PROJECT No.: 0837-067

Benson Falls Regional Park Access Improvement
Tender 20-037

AD-02

ENGINEERS SEAL	GENERAL NOTES

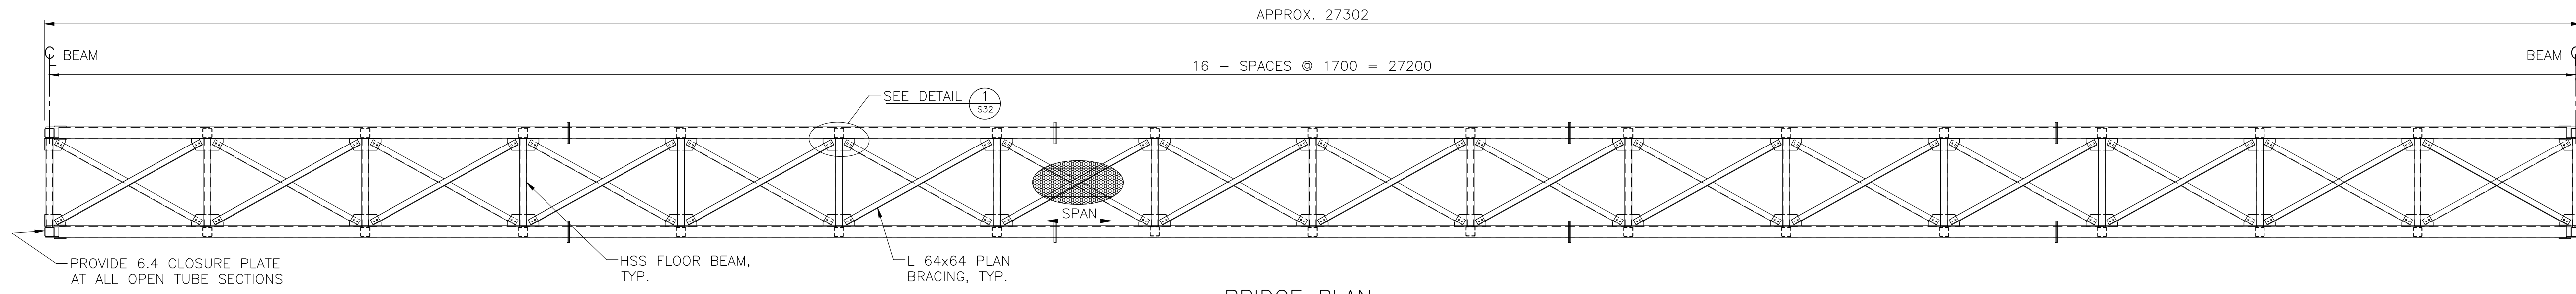
- Q1:** *The note on page S01 -5.0 states the contractor is to have their engineer do the design connections and to use min 19 mm bolts. Do we need to have an engineer review and design the connection details or was that accounted for in your design?*

- A1:** Section 5.7 refers to connections in stair and platform elements not detailed on their respective sheets. For the bridge, connections refer to notes and details on sheets S31 and S32. Bidders must retain the services of a professional engineer to provide sealed drawings for connection details that are different than shown.

CREEK CROSSING
- SITE 1 - TRUSS
BRIDGE, PLAN
ELEVATION AND
SECTION

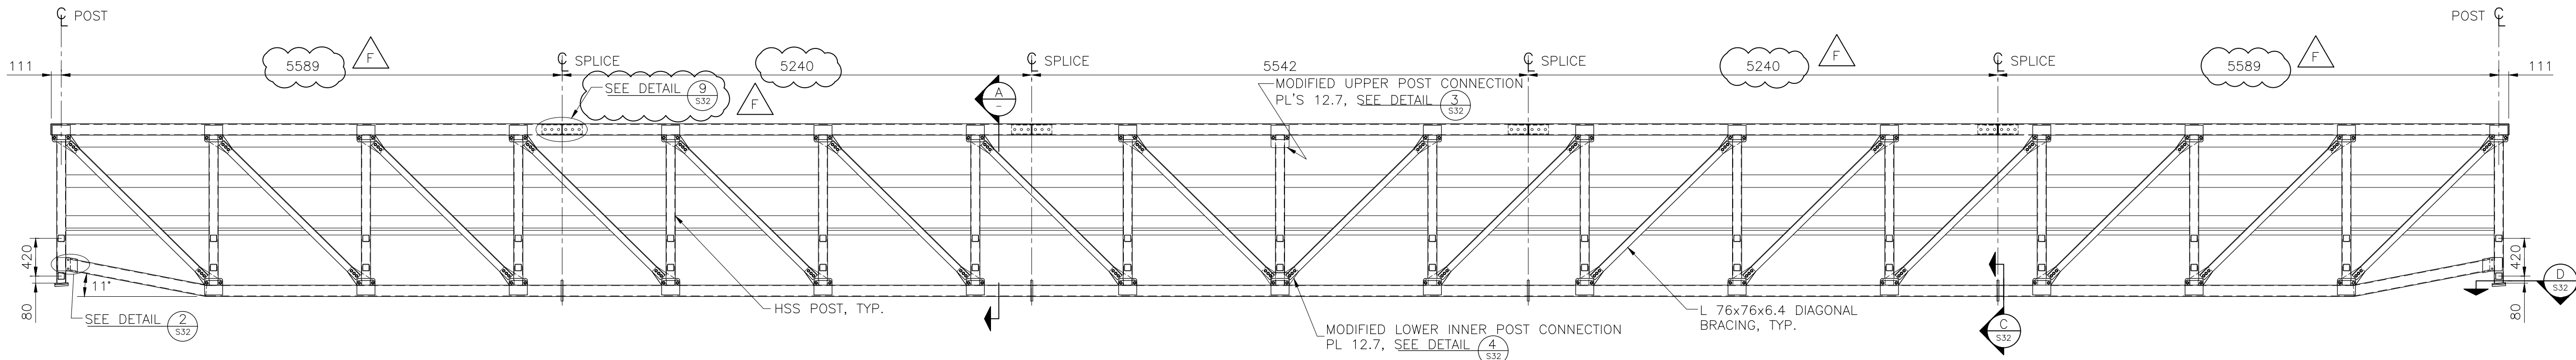
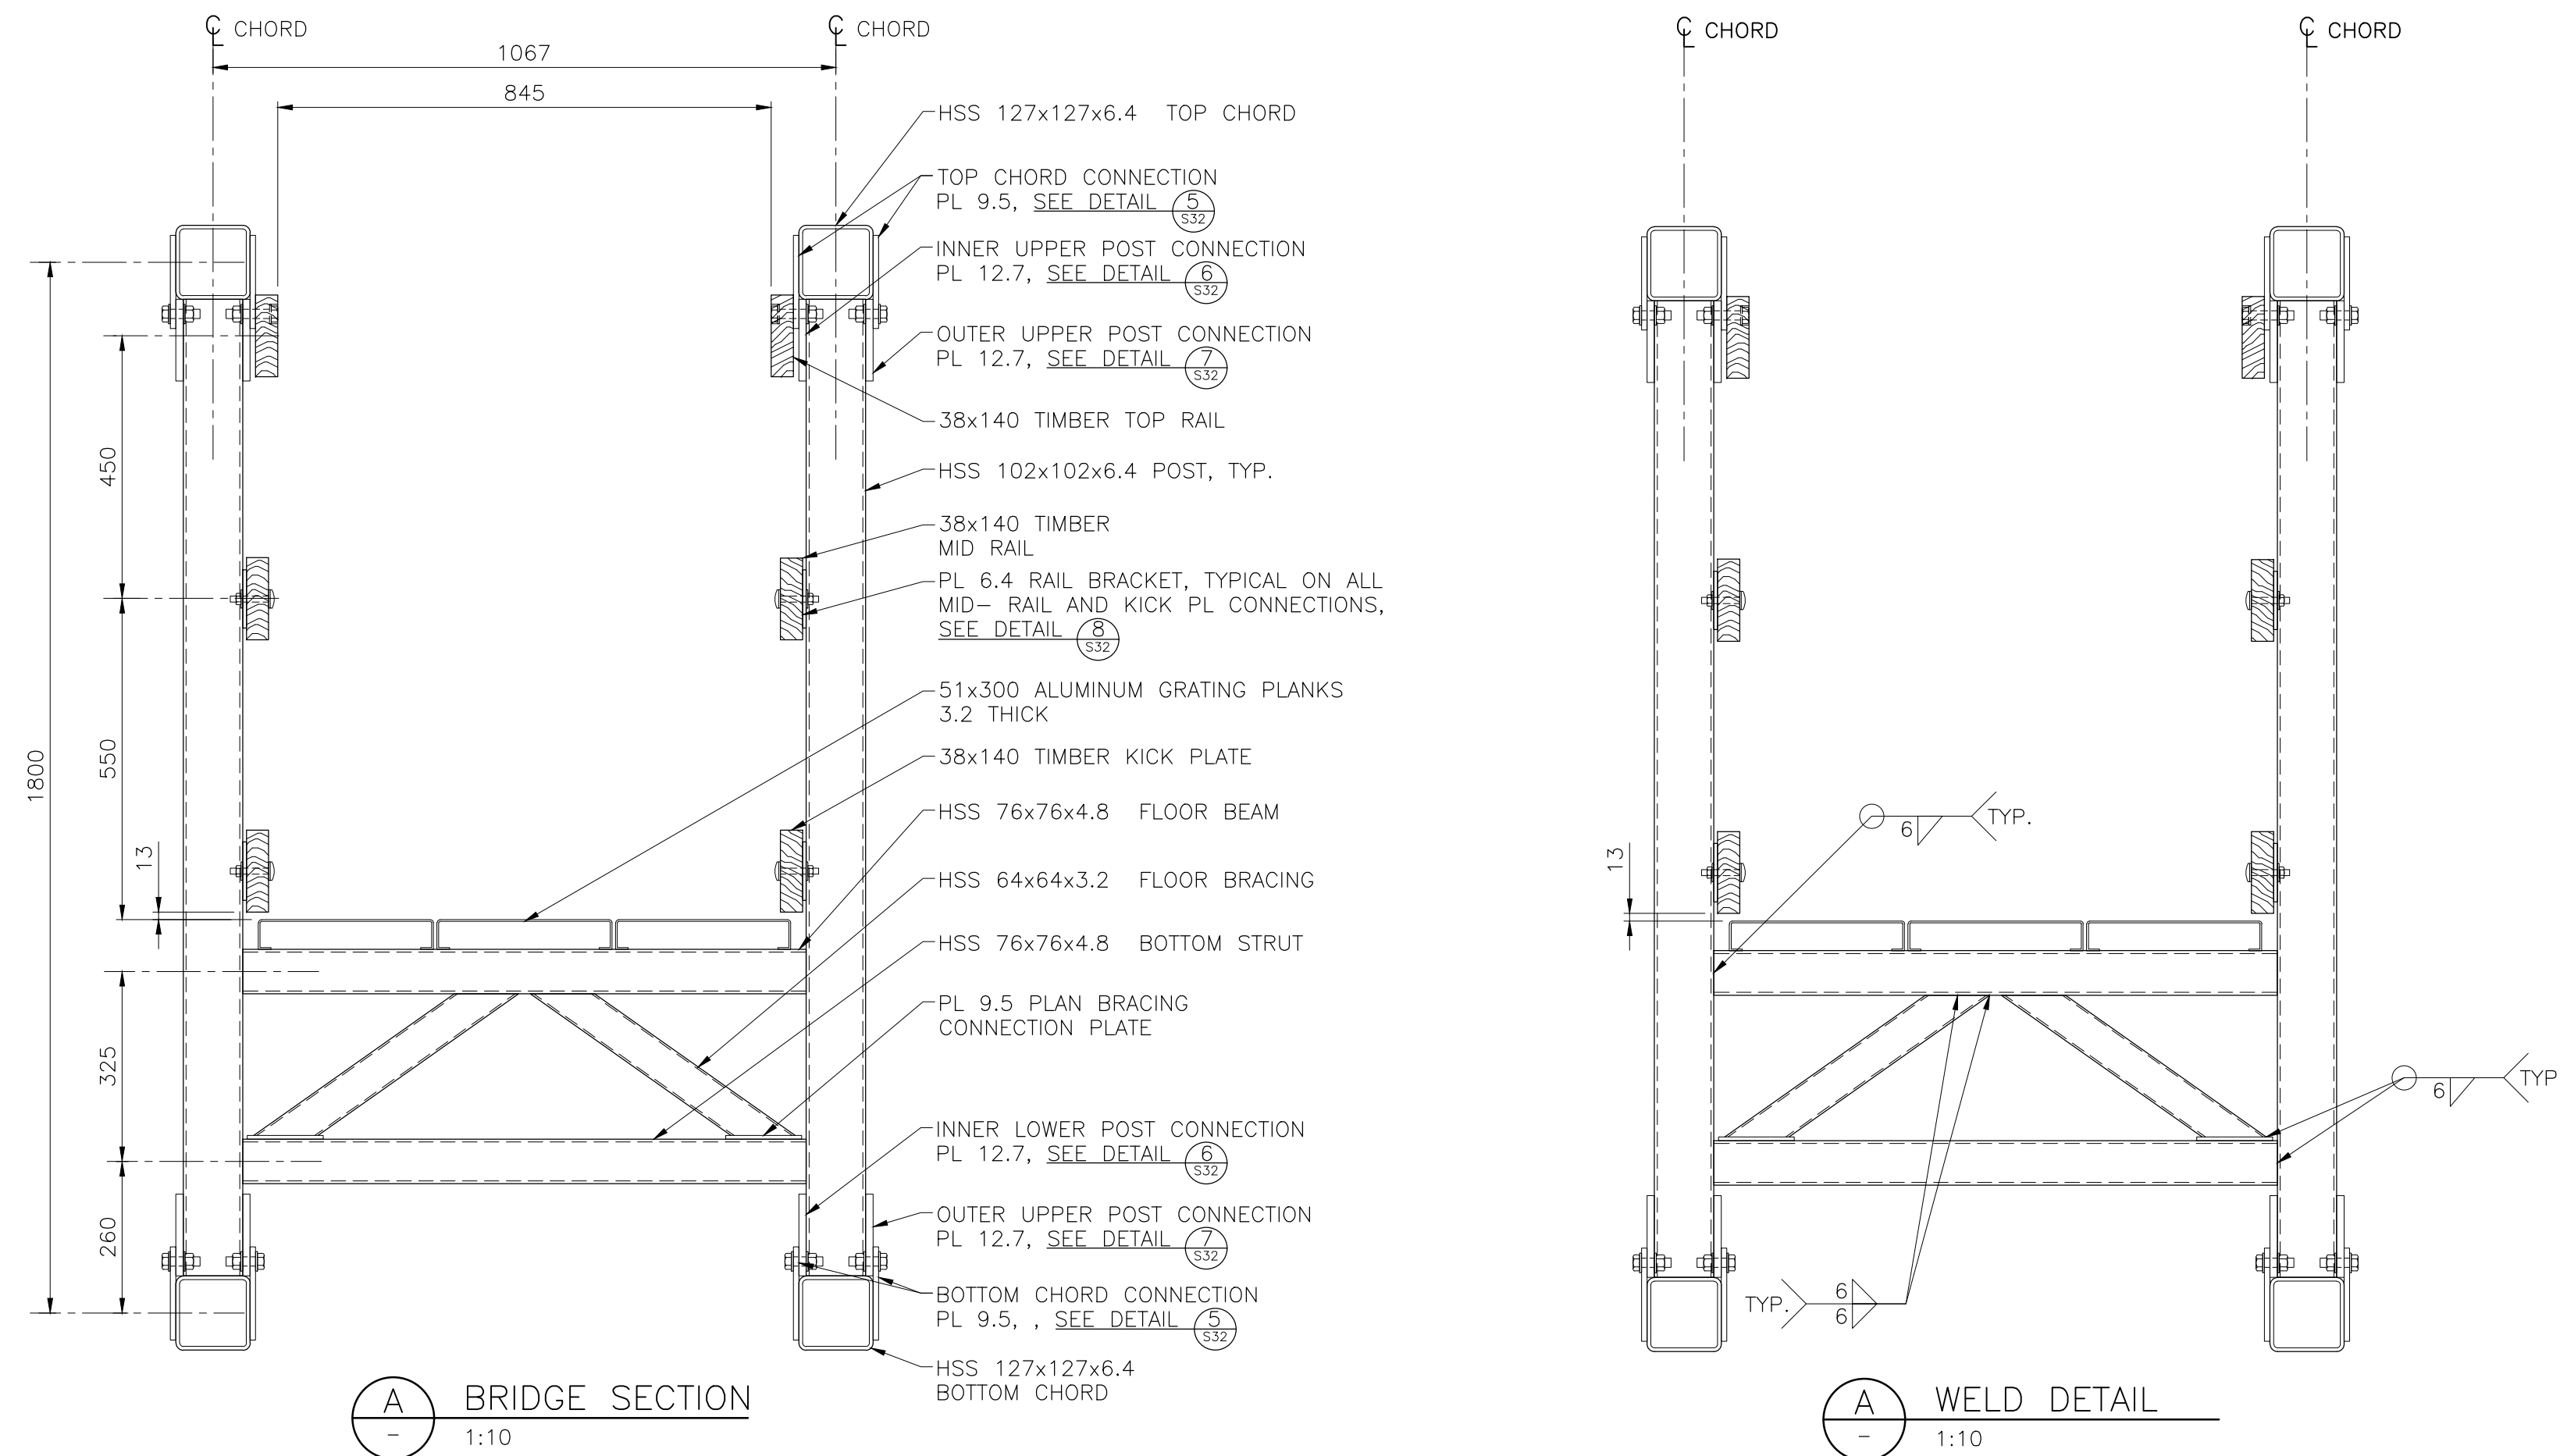
- Q6:** *The drawings show a conflict of length in the bridge can you confirm which length is correct?*
- A6:** Please see attached amended drawings. Note the overall length of the structure remains unchanged. The changes reflect the location of the proposed splice locations.
